WATER WELL PERMIT APPLICATION CEQA REVIEW DECISION

**Stanislaus County Final ISMND Package
Response to Comments Memo**

Subject: **Response to Comments**
Public Draft Initial Study/Mitigated Negative Declaration (IS/MND)
Well Permit Application Nos. 2021-69, 2021-70, 2021-71, 2021-72 and Two Future Permits
Hunter Ranch, Stanislaus County, California

Figure 10
Maximum Predicted Extent of Drawdown Exceeding 5ft (Scenario B)

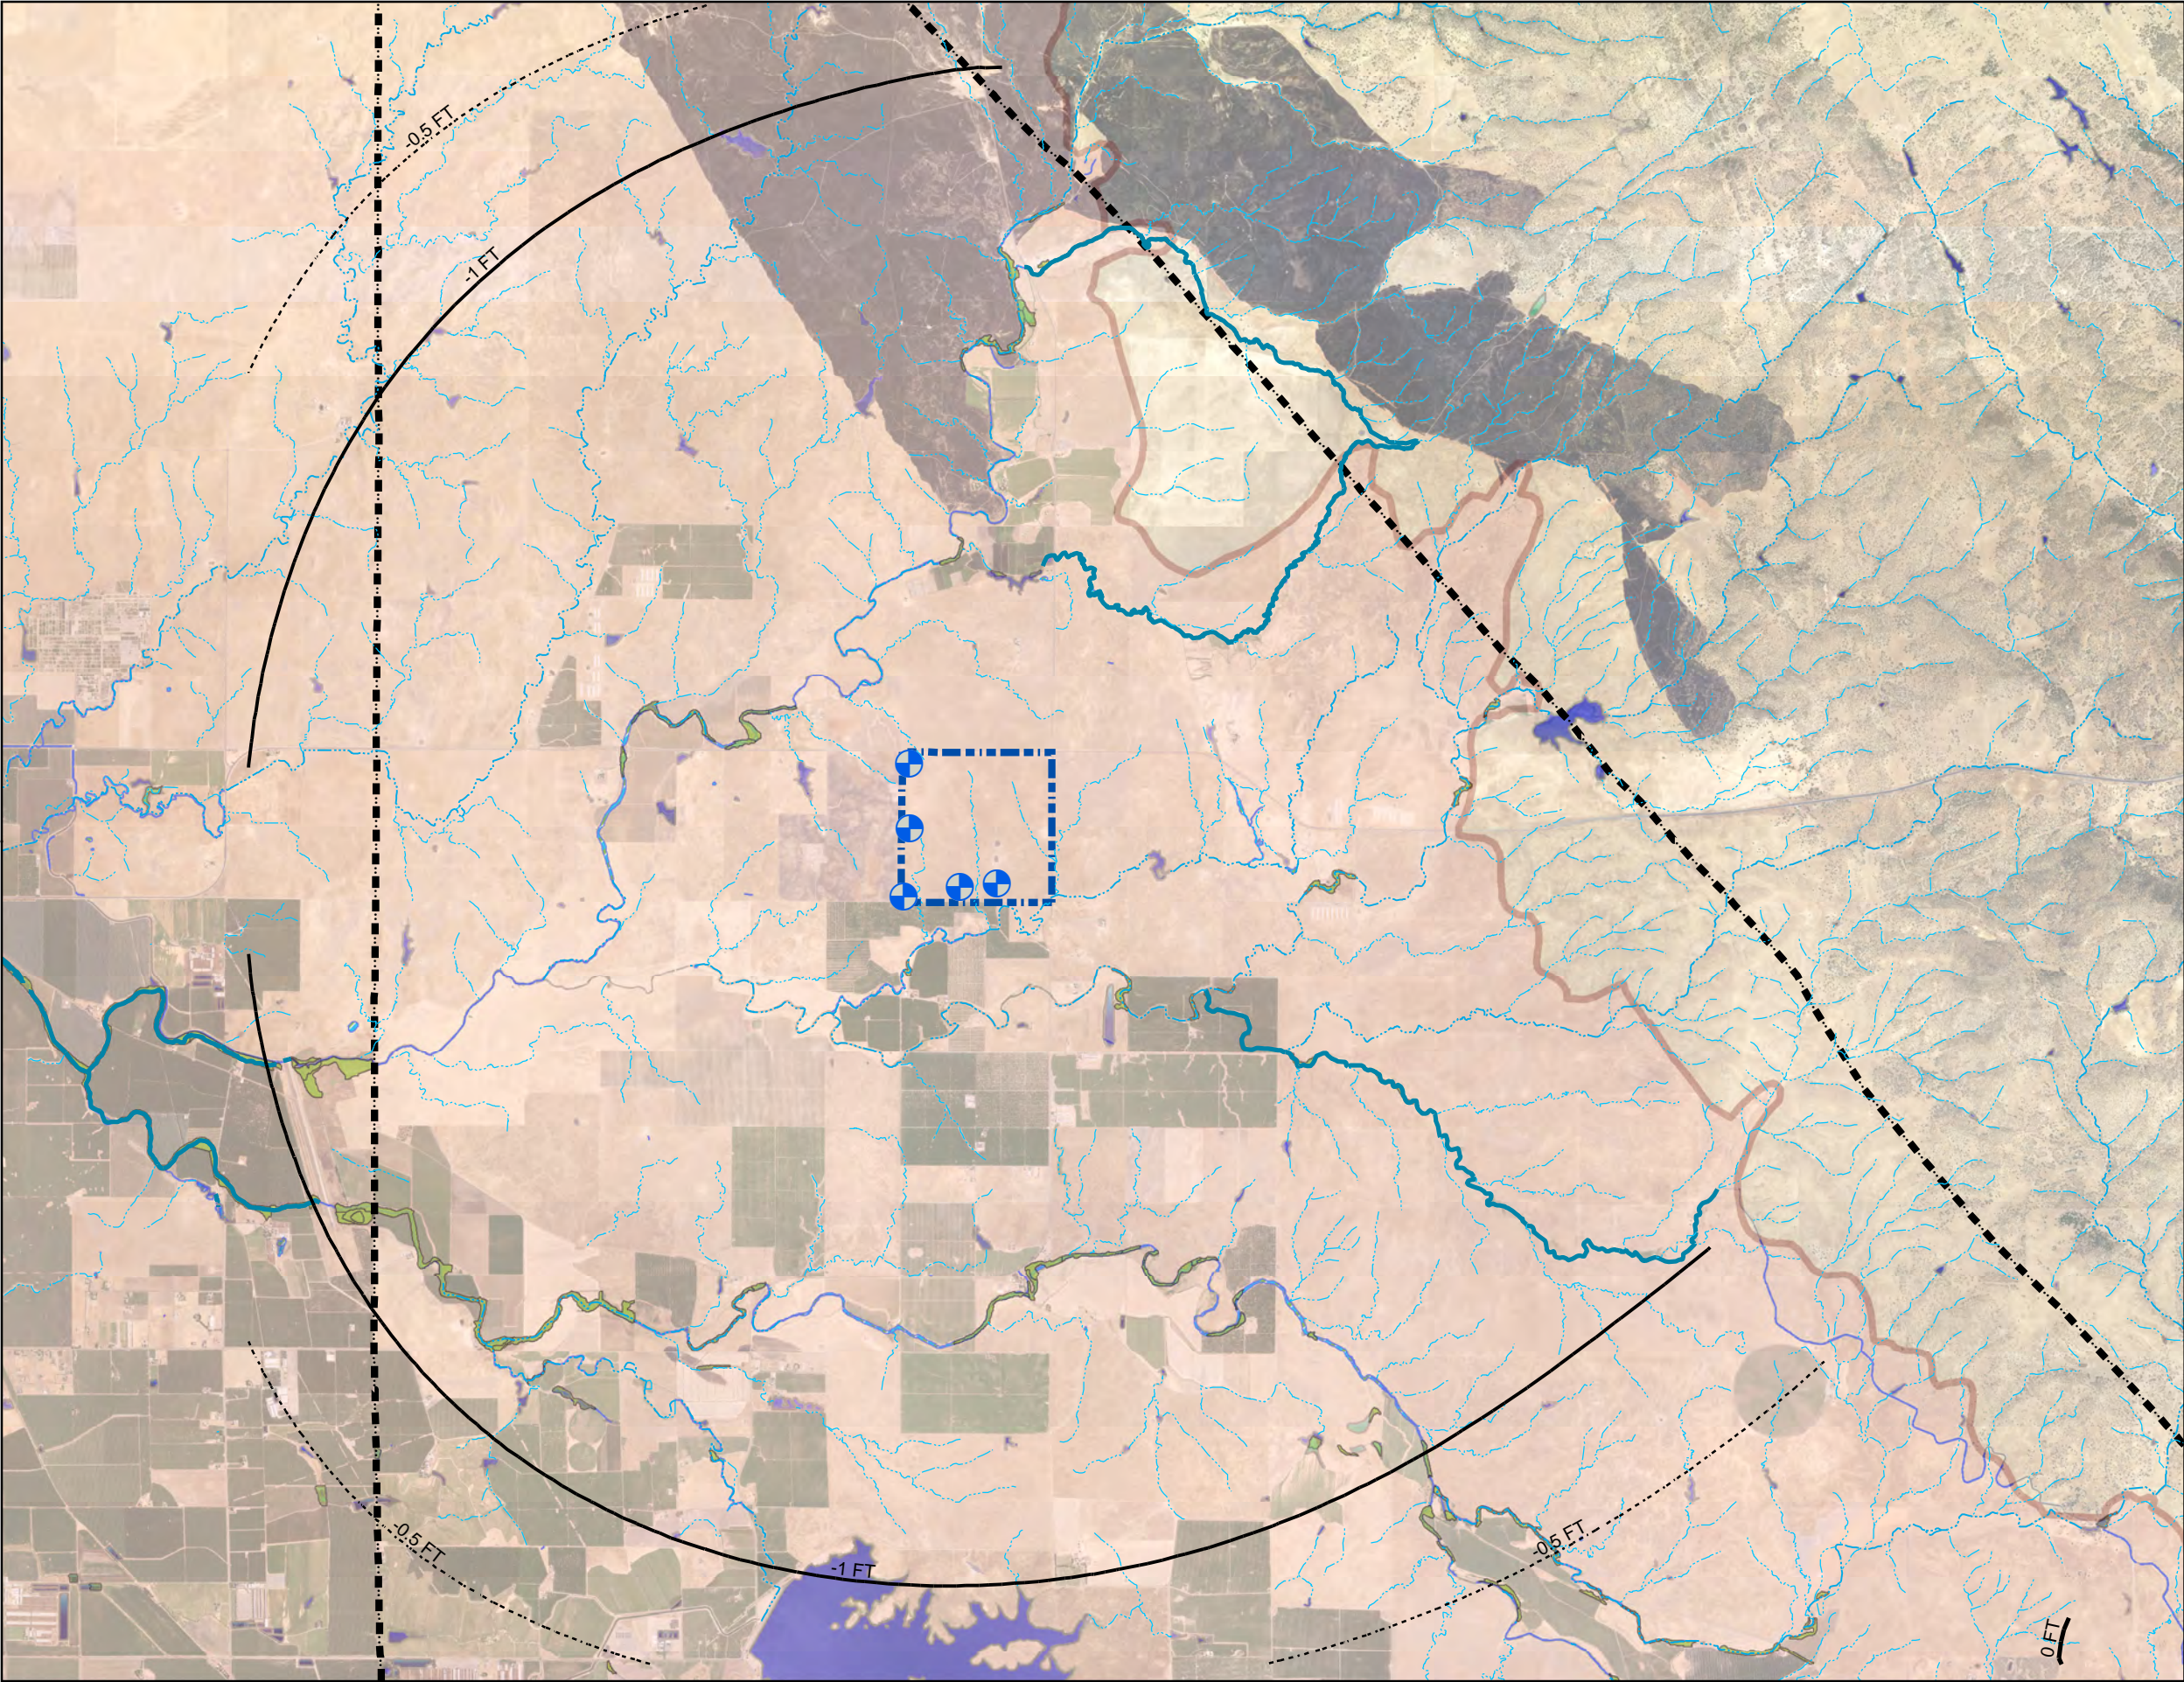
Our ranch well is roughly 300 feet deep (we believe) and is used solely for livestock drinking water for cattle on our rangeland. We have watched range land such as ours change to dry farming then into almonds next to us on our other ranches. Eventually, we had to drill additional wells for livestock drinking water because our water volume dwindles or goes dry. The Hunter Ranch proposal will most likely force us to drill one or more wells at the same depth of the Hunter Ranch proposed wells, to maintain the quality and volume of water which we now have.

- The location of the Hatler Ranch well (the commenter’s well) is believed to have been identified as approximately 3,900 feet north of Highway 4 and 1,200 feet east of Milton Road, as shown on Figures 7 to 10 of the GRIA. As shown on Figure 7, the predicted drawdown at this well after 20 years of pumping under Phase 1 is approximately 4 feet, and the predicted drawdown from combined Phase 1 and Phase 2 pumping is approximately 8 feet (if Phase 2 pumping is initiated). The Hatler Ranch well is reported to be approximately 300 feet deep, so based on an estimated depth to groundwater of approximately 150 feet, the predicted Project drawdown would represent less than 10% of the available drawdown for this well. This amount of drawdown is unlikely to result in an observable reduction in pumping capacity; therefore, the potential impacts to the Hatler Ranch Well is expected to be less than significant.

- The locations of known domestic wells in the area are shown in the GRIA Figure 10, based on information obtained from the Department of Water Resources (DWR), review of aerial imagery and field observations from public roadways. The number and depth statistics for domestic wells for which the DWR has records are also shown on this figure, including both reported active wells and wells that are no longer being used or have been abandoned. The potential impacts from the Project pumping on domestic wells is discussed in the GRIA (pages 19 and 20, and 22 to 25). This analysis provides substantial and sufficient evidence to support assessment of the potential drawdown impacts from the Project to domestic wells and the conclusion that interference drawdown impacts to domestic wells will be less than significant.
